**A RESOLUTION OF THE CITY COMMISSION OF THE CITY OF POMPANO BEACH, FLORIDA, SUPPORTING THE BROWARD METROPOLITAN ORGANIZATION'S 2017-2019 MOBILITY PROJECTS PLAN FOR THE CITY; PROVIDING FOR SEVERABILITY; PROVIDING AN EFFECTIVE DATE.**

**ADMINISTRATIVE REPORT NO.** 15-514

**RE:** Broward MPO 2017-2019 Mobility Projects

# Broward County Metropolitan Planning Organization's 2017-2019 Proposed Sidewalk/Bicycle Improvements

# NE 48th /49th St (Dixie Highway to US1)

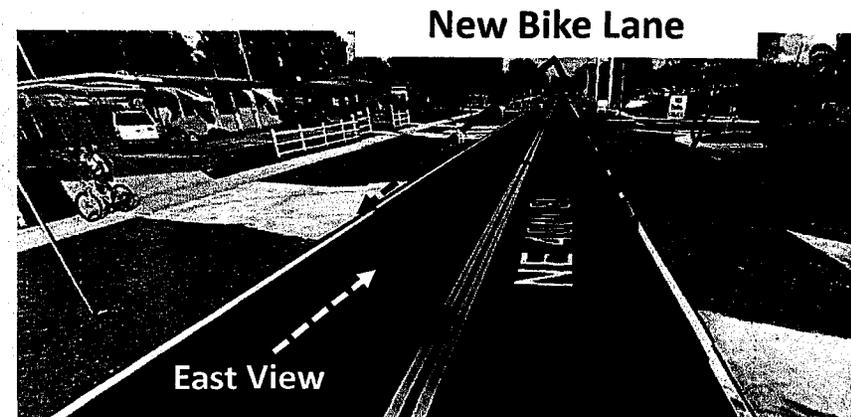
**Comment:** In order to build a five foot wide bike lane on both sides of the street, the project includes narrowing the existing lanes from 12 feet wide to 10 feet wide, and increasing the paved right of way three feet on both sides.

# NE 5th Ave (NE10th Street to Copans Road)

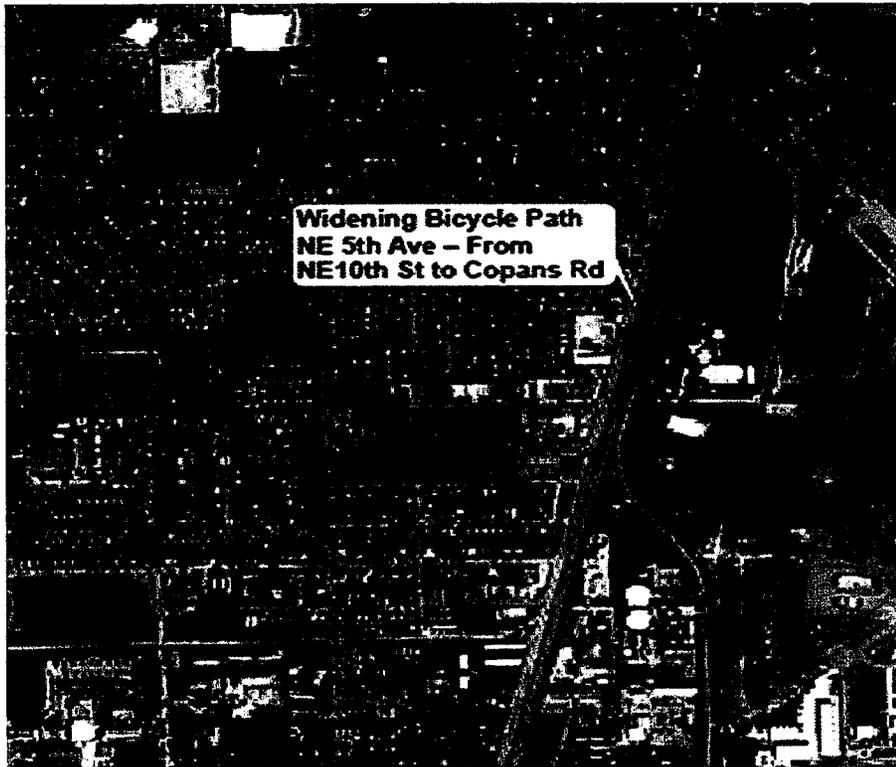
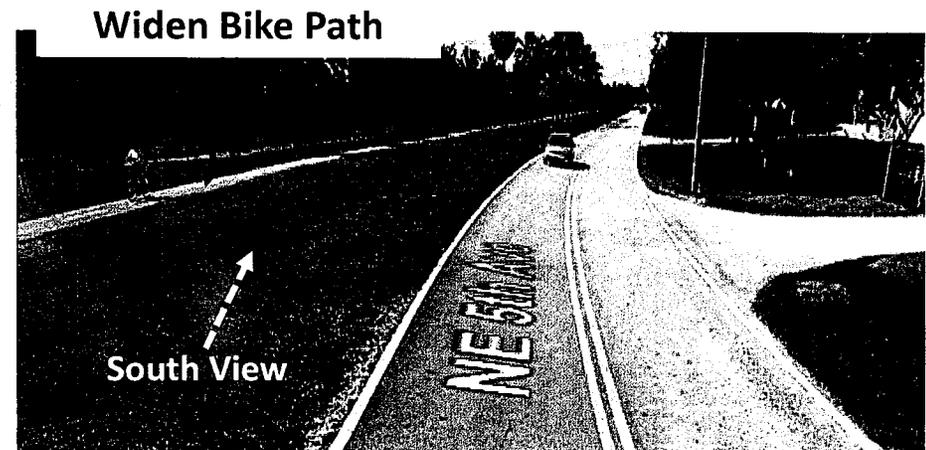
**Comment:** The scope for this project includes widening the existing multipurpose path to 12 ft.

# NE 10th St (NE 5th Ave to US1)

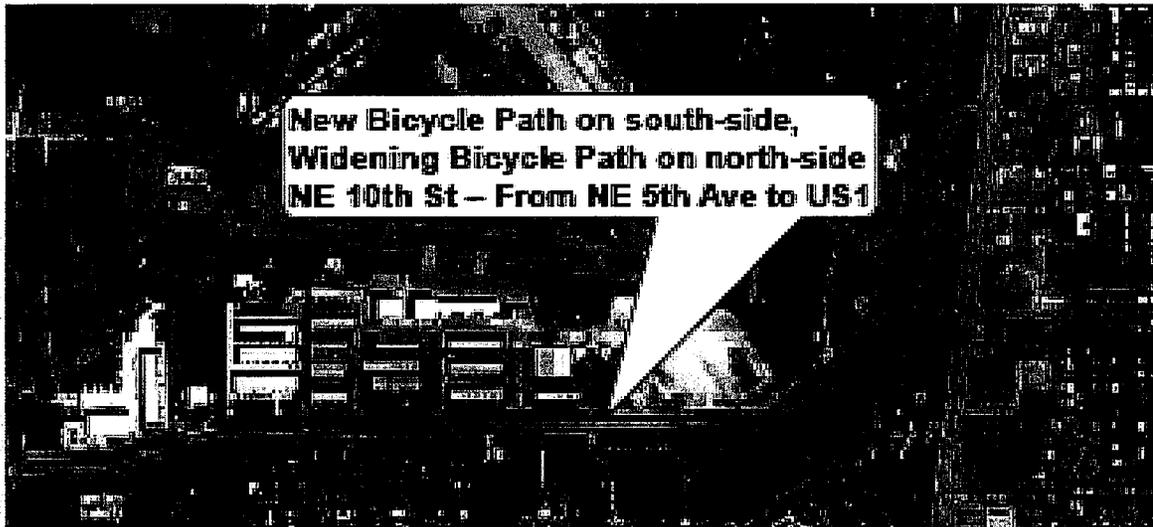
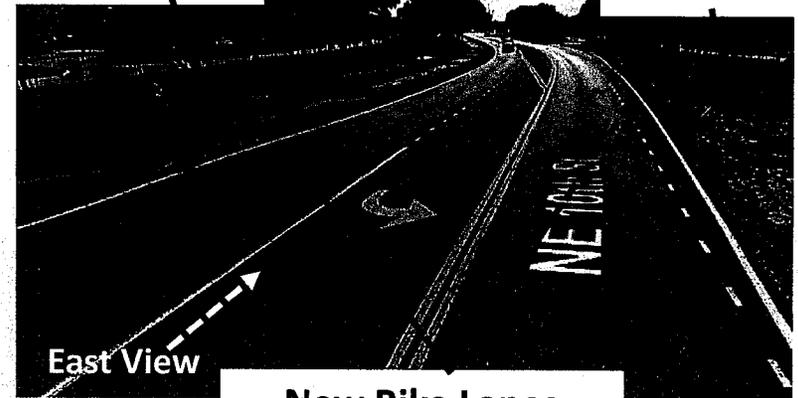
**Comment:** The scope for this project includes widening the existing multipurpose path (on north side) to 12 ft, creating a new multipurpose path on south side of road, and widening road 2 feet on each side to accommodate 5 ft on-street bike lanes on both sides.

# SE 2nd St (NE 11th Ave to US 1)

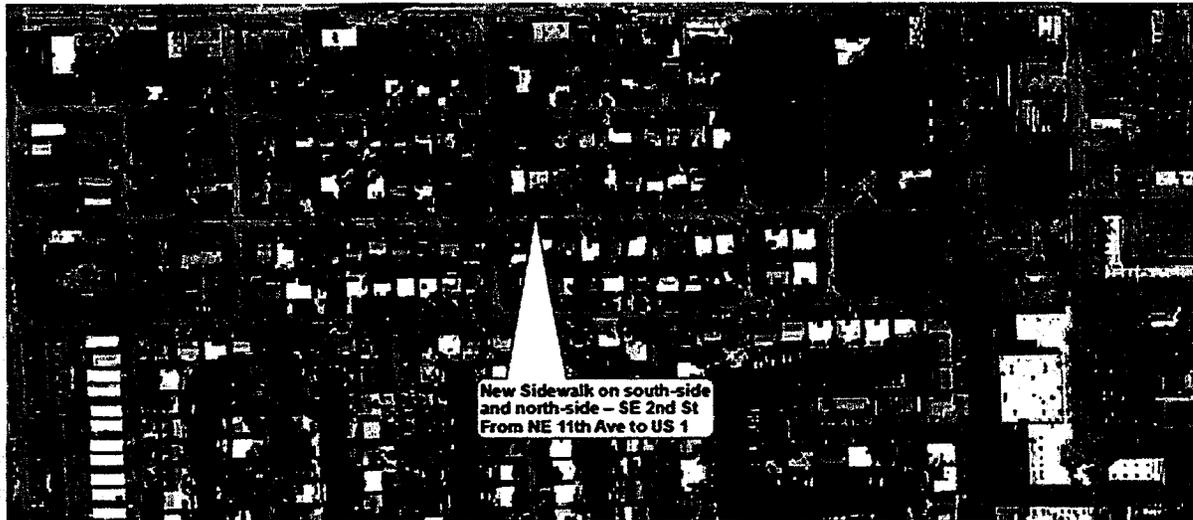
- Don't want sidewalk
- Prefer sidewalks on only one side
- Also want traffic calming - prefer traffic circles
- Concern over trees
- Good for children, walkers,
- Check area w/w  $\approx 13'$  is 15<sup>th</sup> Ave is see if
- add'l dedications would be required to align the street
- Consider bike lane on one side & sidewalk on other
- Supportive of side walker
- Drainage issues on this roadway, possibly caused by resurfacing
- less grass/lawn maintenance
- likes sidewalks - concern for trees

**Comment:** Several abutting property owners attended the meeting. Property owners expressed concern over existing flooding issues and that they prefer the city to address flooding. Further they prefer city invest in traffic calming mechanisms.

JG Note: NPO doesn't pay for relocation

### 13.6. POMPANO AIR PARK JOGGING AND BICYCLE TRAIL

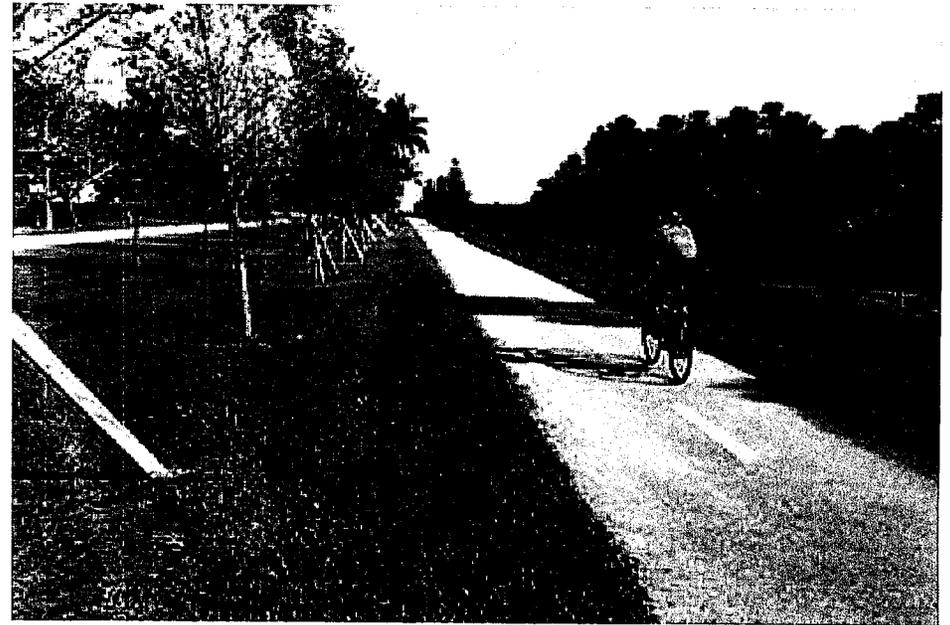
During the final workshop it was expressed that the present trail is not wide enough to accommodate both pedestrian and bicycle traffic. It is recommended that the Air Park Jogging and Bicycle Trail be widened to ten (10) feet to allow adequate flow of both pedestrian and bicycle traffic.

**Comment:** Proposed MPO Project is consistent with the recommendations regarding the Pompano Air Park Jogging and Bicycle Trail

Figure 13.F - Central Area Bicycle Boulevard

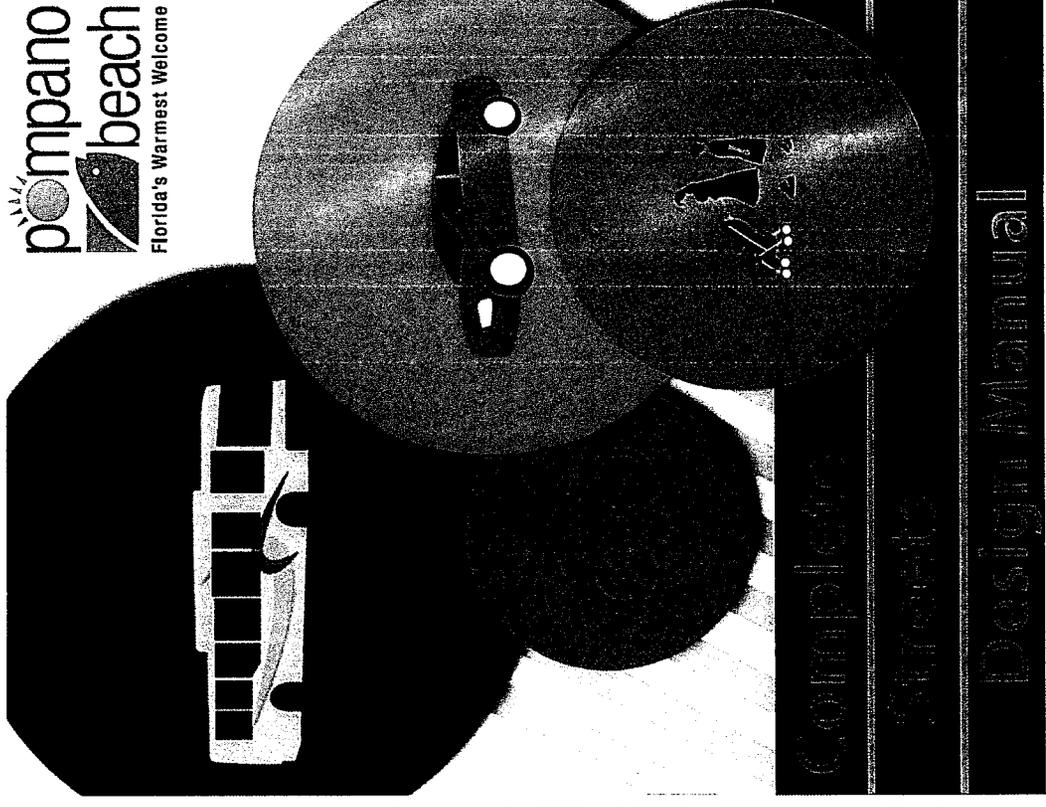
*Comment:* Proposed MPO Project is consistent with the "Central Area Bicycle Boulevard Plan"

Comments  
Mid Section

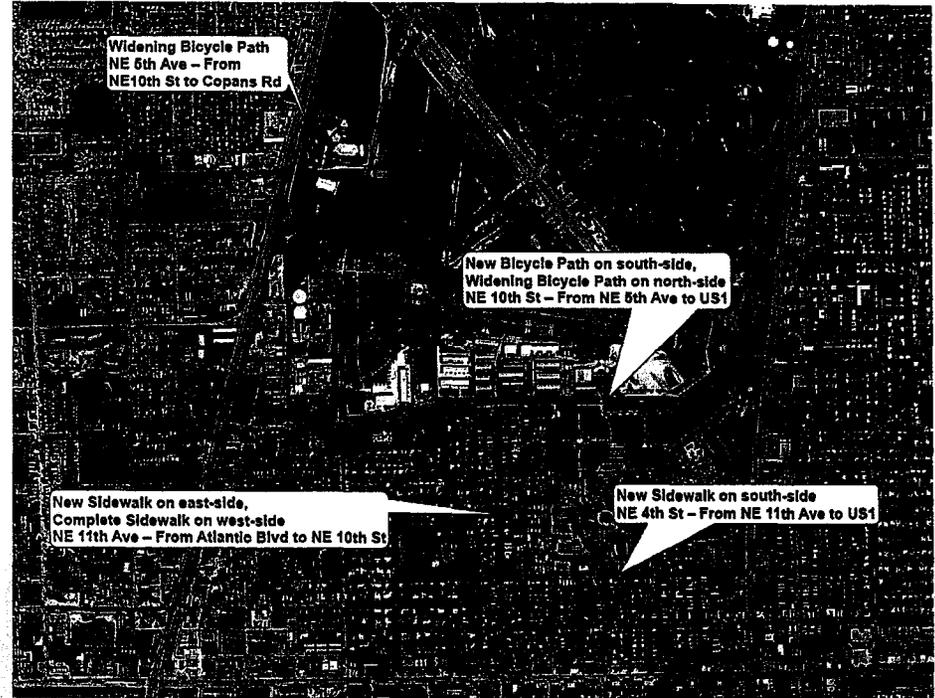
Trees & sprinklers will be ripped out,  
no parking, will park on sidewalk

THE WEST SIDE IS CLEAN WITH A PRESENT SIDEWAY  
NO TREES NO GARDENS OR DRIVEWAYS HAS TO BE  
MUTILATED FROM THE 10<sup>TH</sup> ST TO ATLANTIC.

THE NEW PROJECT WILL BE CHEAPER IF THE PROPOSED  
CYCLE WAY IS BUILT ON THE WEST SIDE OF 11<sup>TH</sup>  
AVENUE - ADAMIO BAZZANO 754-245-4600

NE 4<sup>TH</sup> ST → waste of taxpayer dollars to  
duplicate sidewalk that is already complete  
on the north side of the street

2. sidewalk on south side would cut  
yards in half & disrupt landscaping/parking  
and privacy of properties built in the  
1950's & 1960's.

3 reduction of driveway length would  
force parking on swale in many cases  
4. There has been no change in density  
of this area since the 50's & 60's. We don't  
have any need of this proposed sidewalk.

**Comment:** Several abutting property owners attended. Some were concerned about the sidewalk proposed for NE 11<sup>th</sup> Street. Also concern about the new sidewalk on NE 4<sup>th</sup> street was expressed.
